DEVELOPMENT APPLICATION

**RESPONSE TO MINISTERIAL INFORMATION
REQUEST**

Mount Emerald Wind Farm

September 2014

Figure 1 – Location of representative dwellings in relation to project site

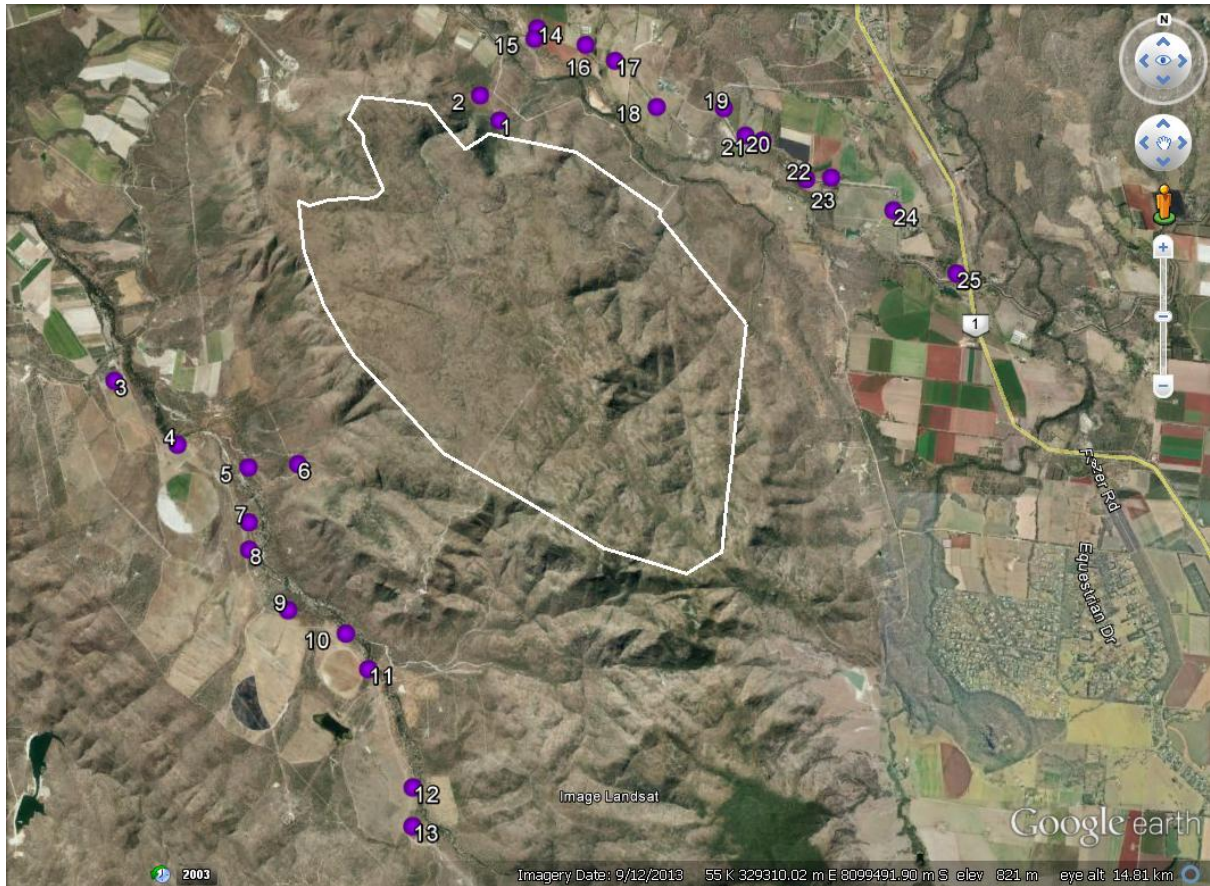
- 5. *The Noise Assessment report has nominated an indoors/outdoors noise reduction level of 10dB, and a 20dB reduction for air conditioned dwellings. A reasonable outside to inside limit is critical to the assessment of this development and therefore, field assessments should be carried out at a sample of affected or similar receivers to confirm the outside to inside linear (dB(Z)) and dB(A)) noise reduction as originally requested.***

Following discussions with Department of State Development, Infrastructure and Planning representatives regarding the noise impact assessment works the proponent was asked to undertake a review of the dwelling structures in the vicinity of the proposed Mount Emerald wind farm to assist in determining appropriate building sound attenuation levels.

In undertaking this review a representative batch of dwellings in relative proximity to the wind farm were photographed and an assessment made as to the basic components comprising the structure of each. Confirmation was also made as to whether a dwelling included air conditioning.

The locations of the assessed dwellings are shown in the figure below.

The results of the site investigation and the attenuation estimations are provided for each location in the table below. A more detailed account of each assessment can be found in Attachment C.

Figure 2: Wind Speeds during the background noise monitoring period

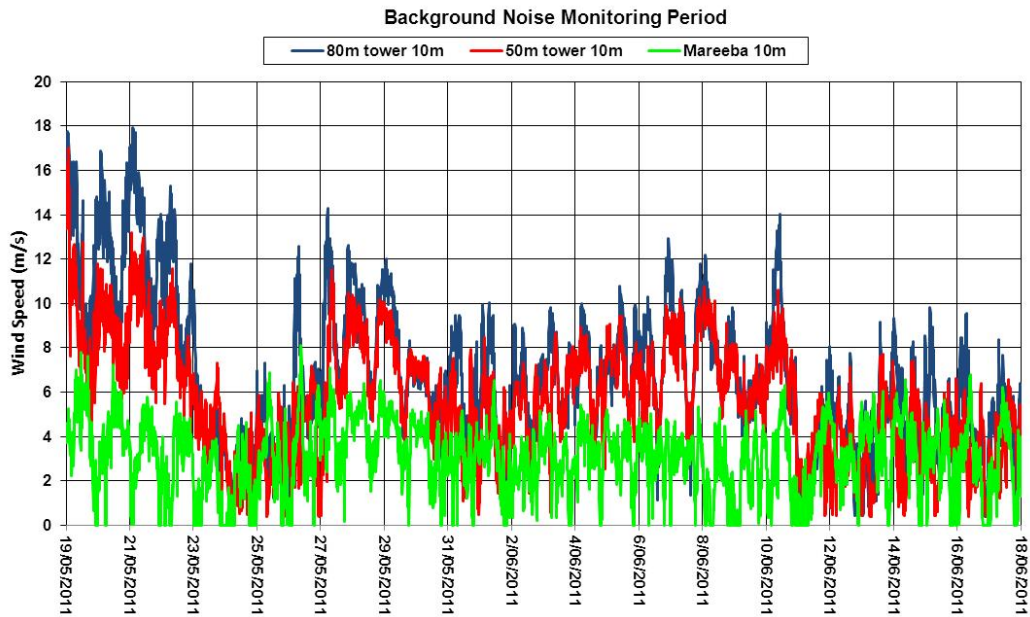
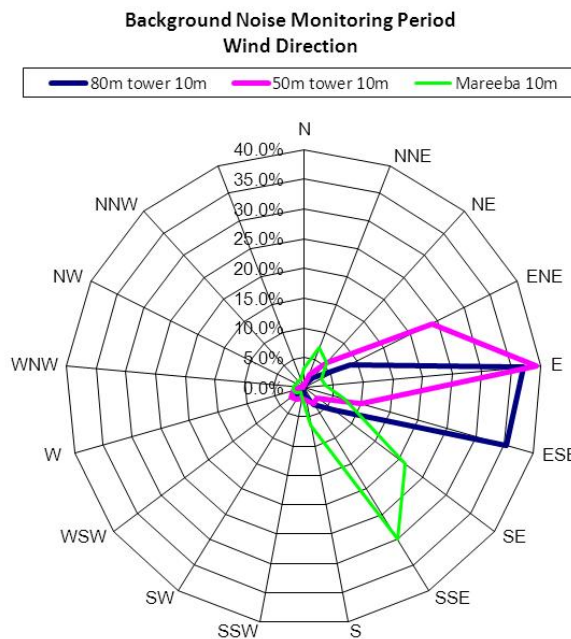
- 7. **Provide correlation between wind speed at the residence and wind speed at the towers. This needs to be provided in tabular form or similar.**

It is difficult to understand the relevance of the request for wind data at the residence. When conducting background noise measurements, the noise levels at the residence are recorded against the wind speed from the proposed site at the particular point in time. The site wind speeds are also used to provide the estimate of wind farm noise and thus compared to the background at the residence. This can be done as sound emitted from a wind turbine is known from field measurements and is guaranteed by the manufacturer for the range of wind speeds at the turbine. In this regard the actual wind speed at the residence affecting the background noise level at the particular point in time is not relevant.

Given the reliance on site wind data, no wind data records were collected at the background monitoring locations.

To provide a response to the information request a nearby Bureau of Meteorology (BoM) site was used as a representative of the surrounding district. The most suitable site was the Mareeba BoM located at the airport some 15km from the site. This site was chosen over the closer Walkamin BoM as it provided for a longer period of automatic data collection.

A table showing the various correlations and plots of wind speeds and directions during the monitoring period are shown below.

Figure 4: Turbine sound power level data, including estimated levels at low wind speeds

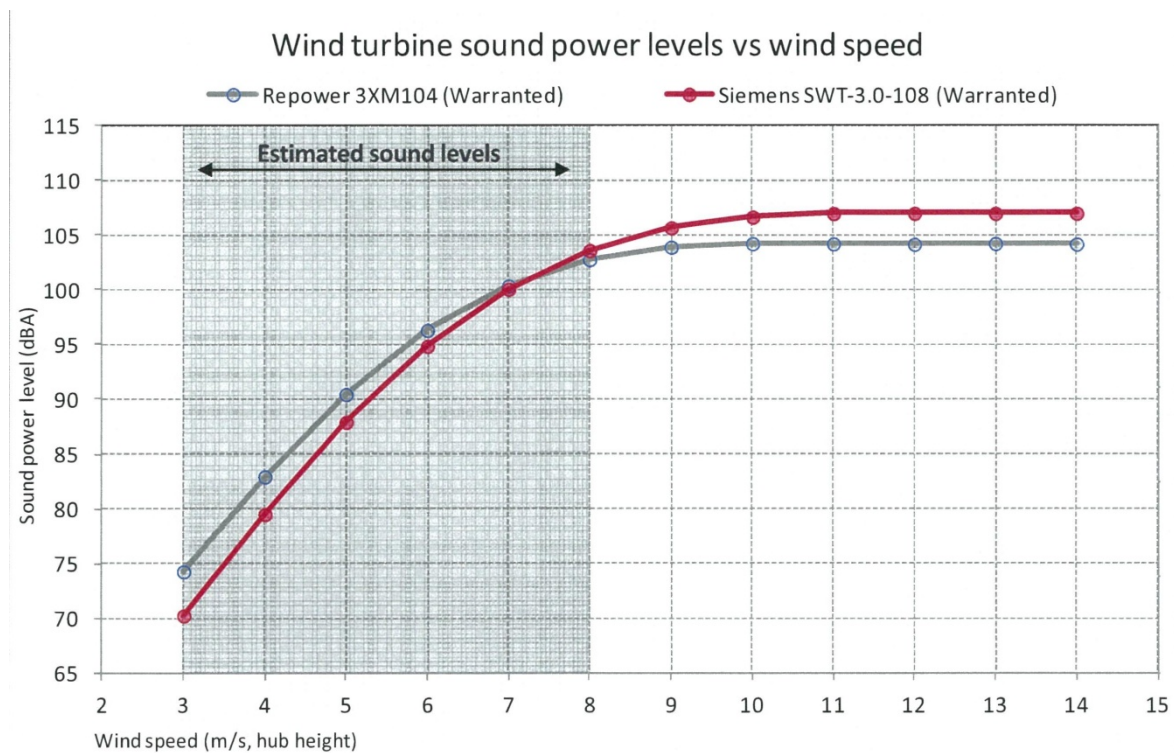
8. ***The current draft Queensland planning guideline for wind farms recommends a limit of 35 dB(A) rather than 40 dB(A) for audible noise. In addition NZS 6808:20109 (referenced in the Mareeba Shire Planning Scheme) prescribes that if there is a difference of 8 dB or more between evening and night-time then the higher amenity criteria of 35 dB(A) should be applied. This does not appear to have been investigated in the report. To assess this averaged background noise levels for evening and night time at the receiver, monitoring locations should be provided and an assessment undertaken against the identified standard.***

Attachment D details available sound power level data for the proposed turbines. This data has been provided for the hub height wind speed range 8 m/s to 14 m/s. As noted in Step 3 of the NPI method, wind farm sound levels also need to be quantified at wind speeds below 8 m/s. In the absence of any manufacturer data for lower wind speeds, this assessment of NPI is based on extrapolated sound power level data, as illustrated in Figure 4.

Figure 5: Attachment I DTM Simulations – Viewpoint Locations and identified Ridge Lines

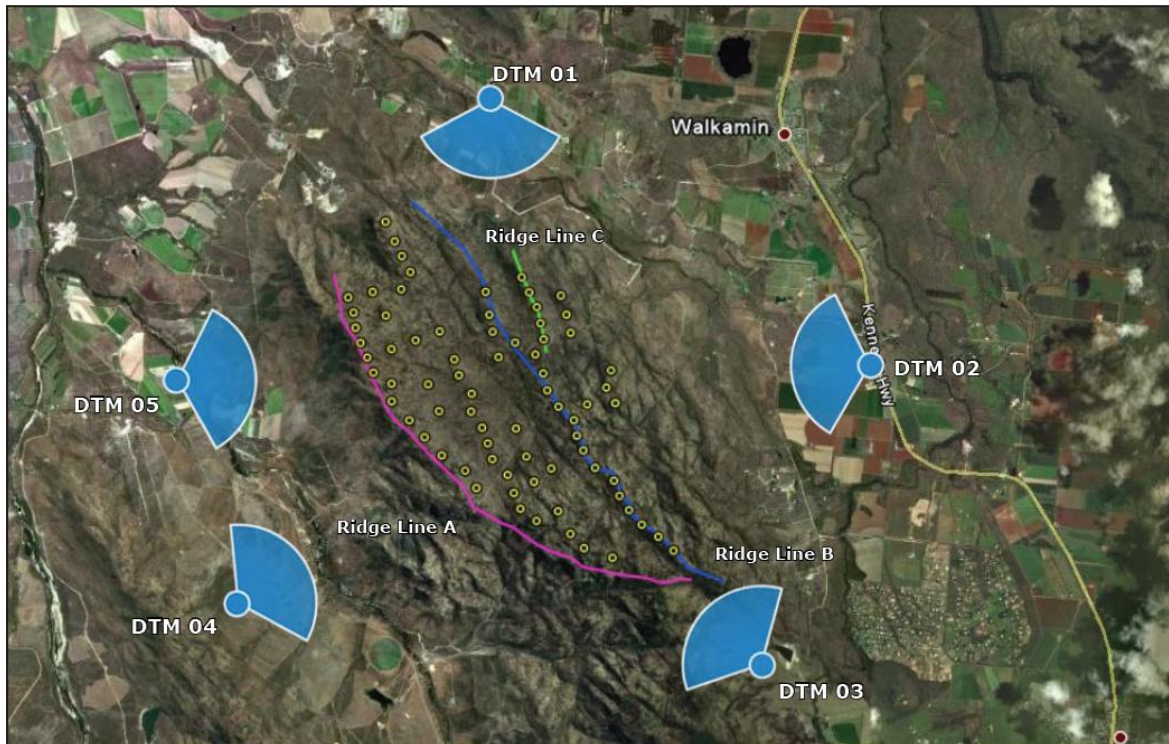
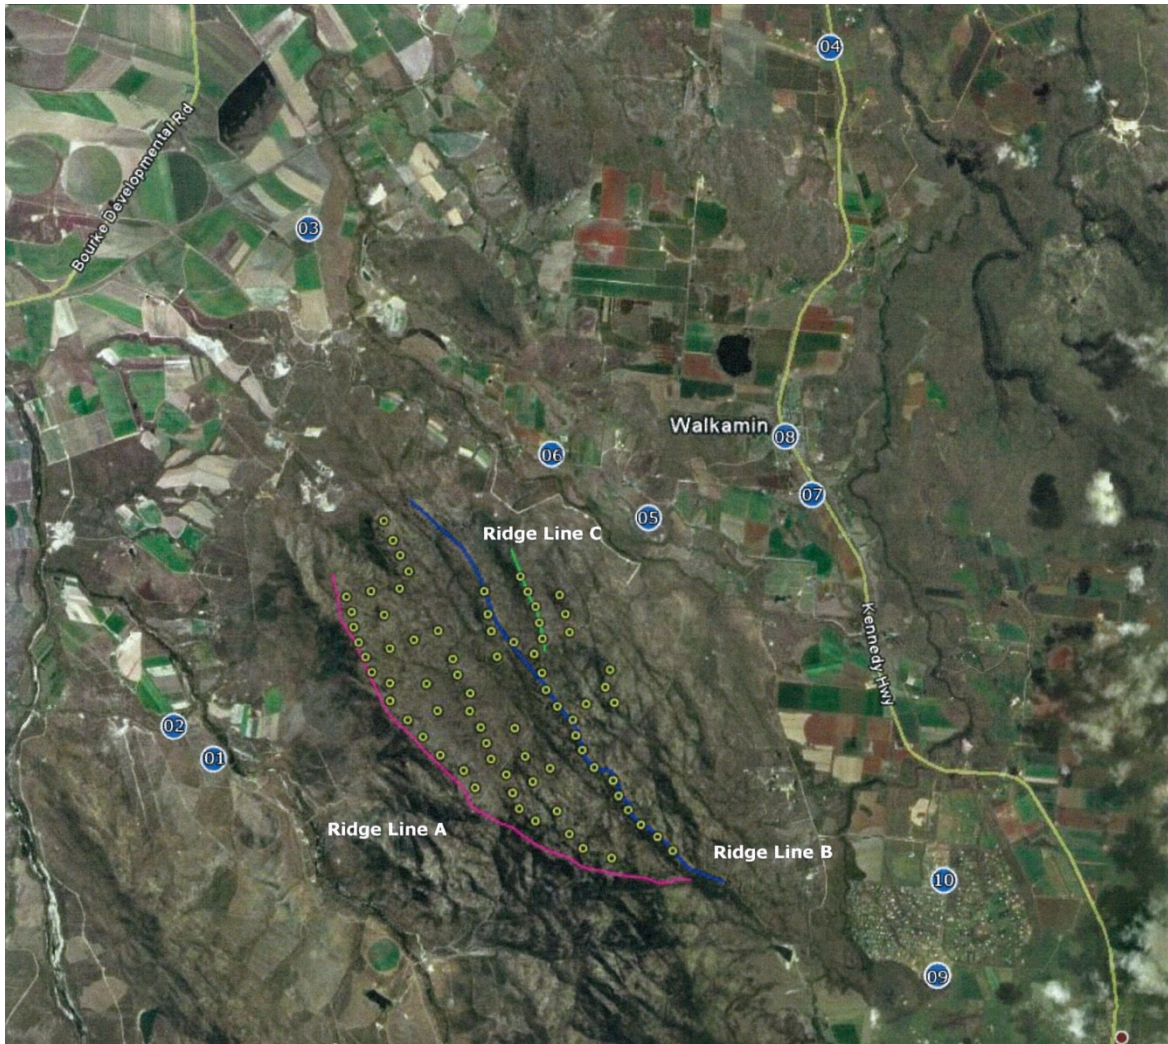
b) identification of site ridgelines and their elevations as seen from various viewpoints

Viewpoint locations and identified ridge lines are shown in the figures below.

Figure 7: Estimated total number of workers during construction stage (24 months)

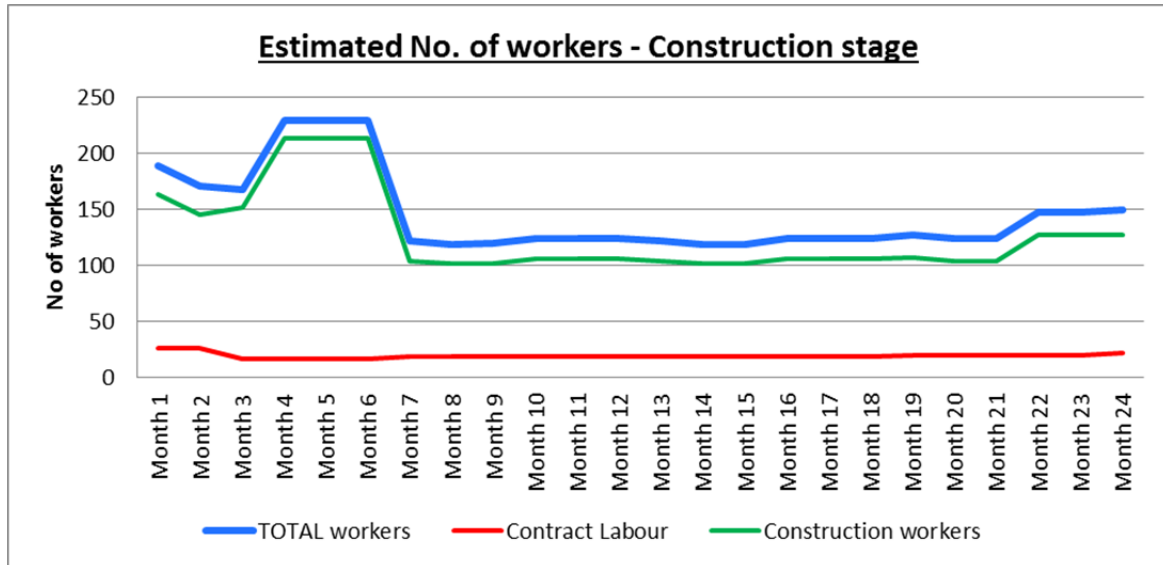
25. *Provide further information on how staff travel to site can be managed in a way that will allow the maximum number of staff vehicles to remain below 30 vehicles per day (as indicated in the Traffic Impact Assessment).*

Based on the information reviewed, the SKM 2011 TIA report assumes a maximum of 30 vehicles per day for workers during the construction stage of the project. The SKM 2012 technical report outlines in detail the estimated number of workers per month for the two year construction phase. Figure 7 summarises the estimated total number of workers during the construction phase (based on the information provided within Attachment N - Appendix D (From SKM 2012 Appendix B)). Figure 7 outlines the total estimated workers for the project during the construction phase (blue line) which includes the estimated construction-related workers (green line) and the estimated skilled/unskilled contract labourers (red line).

The estimated maximum numbers of workers expected to be on site during month 4 to month 6 of the construction phase is approximately 229. Of these 229 workers, 16 workers will be contract skilled and unskilled labourers and are expected to arrive and depart the site via individual or shared private vehicles.

Based on the assumptions above, the maximum number of trips generated by the estimated number of workers during the construction is expected to be 16 vehicles per day, which comprise eight 30-seater buses and eight light vehicles. To provide a robust assessment, a nominal 10 additional vehicles per day has been added to allow for unscheduled visits, deliveries, private vehicles, miscellaneous tasks, and for construction workers who need to bring their own vehicles with trade specific tools. This makes an estimated total of 26 vehicle movements at the site per day.
